REMARKS**Objections to the Drawings**

Appl'n No.: 09/666,524
Title: SURFACE MOUNTED AND SCANNING...
Inventors: Neil J. Goldfine, *et al.*
Annotated Marked-Up Drawings

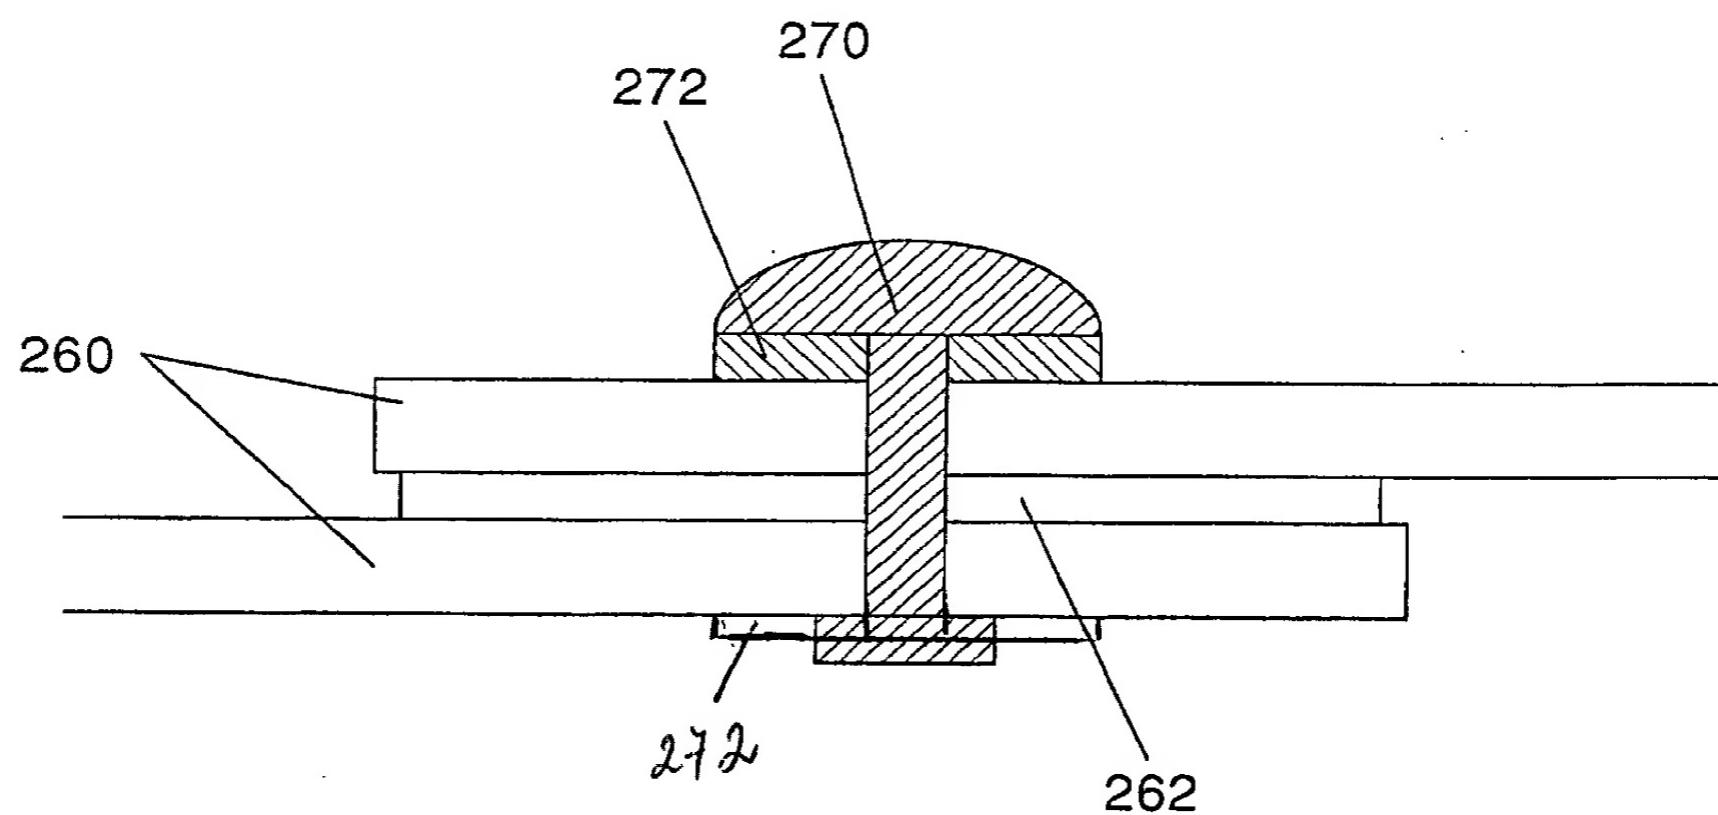
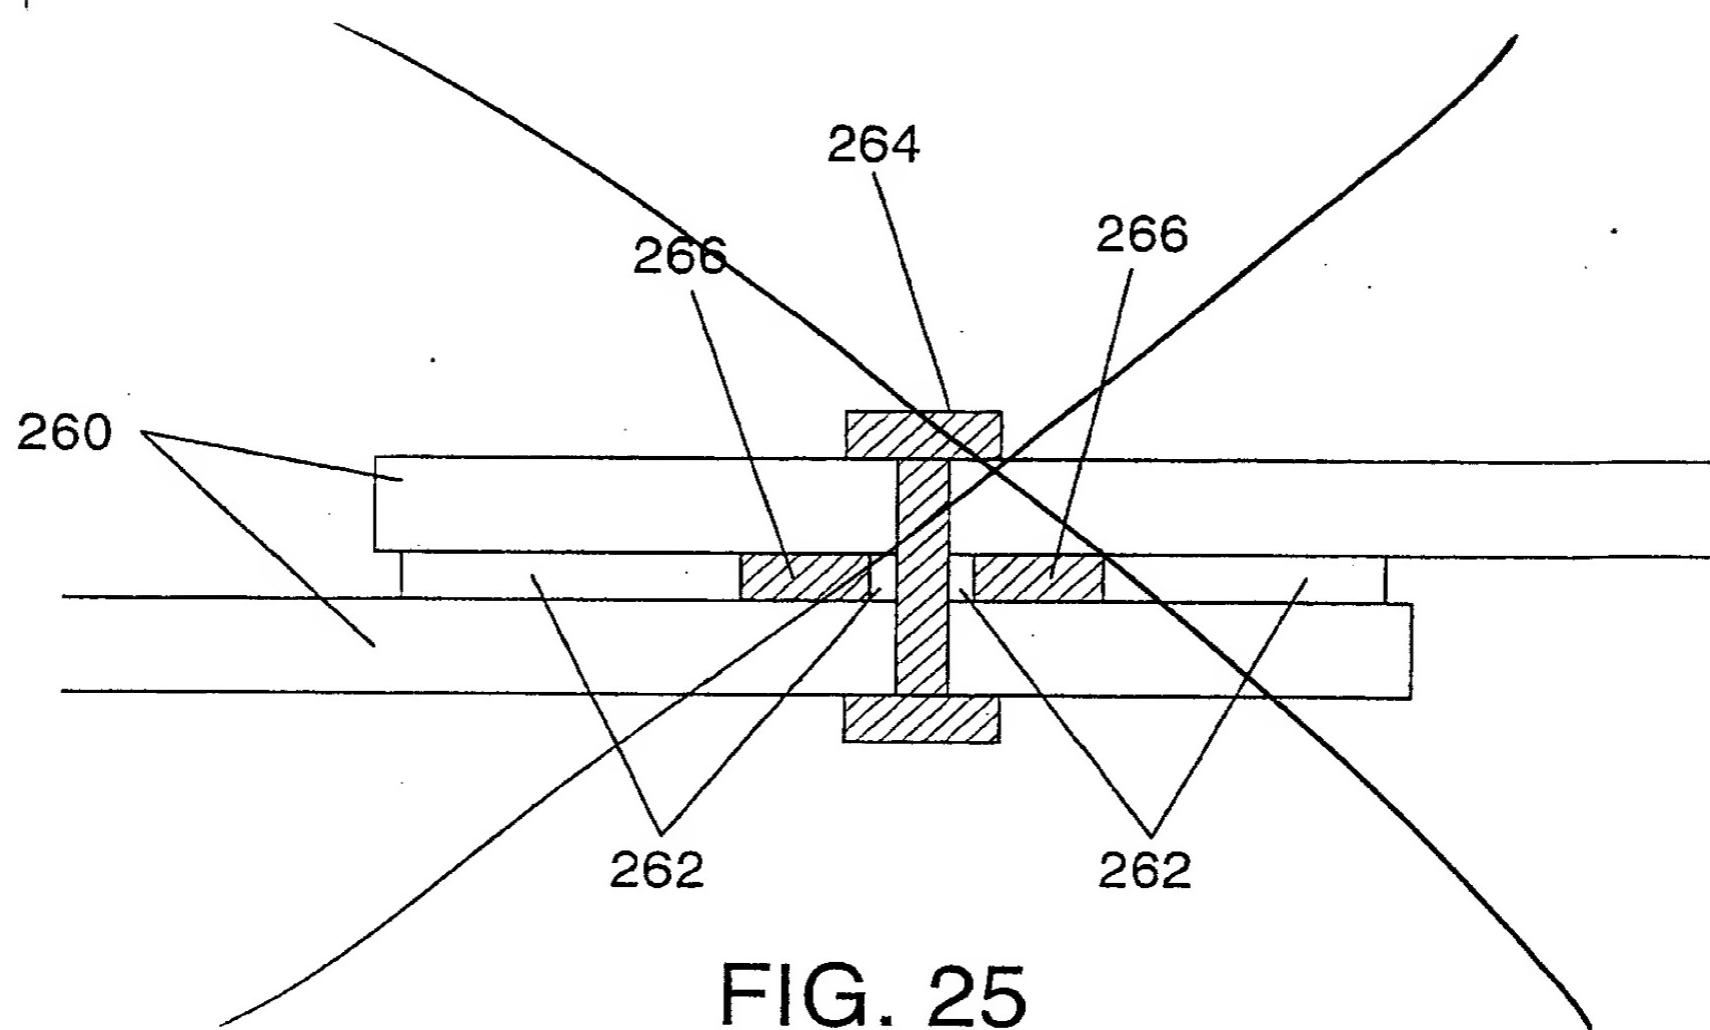
The drawings have been objected to under 37 CFR 1.83(a) as not showing every feature of the invention specified in the claims. The Applicants respectfully disagree. However, to further the prosecution of this application, Figs. 26 and 28 have been amended and new Fig. 28b has been added. No new matter has been added.

With respect to Claim 109, illustrated in Fig. 26, are two sensors 272 attached to the test substrate at both ends of a fastener.

With respect to Claims 171 and 174, Figs. 28 an 28b illustrate a pair of sensor arrays around fasteners. These sensor arrays have sense elements at different radial positions, as shown, for example, in Fig. 27a.

With respect to Claims 161 and 118, the new Fig. 28b illustrates drive conductors connected together.

With respect to Claim 116, Fig. 28 illustrates the drive and sense element connectors so that the separate drive connections to each sensor are apparent.
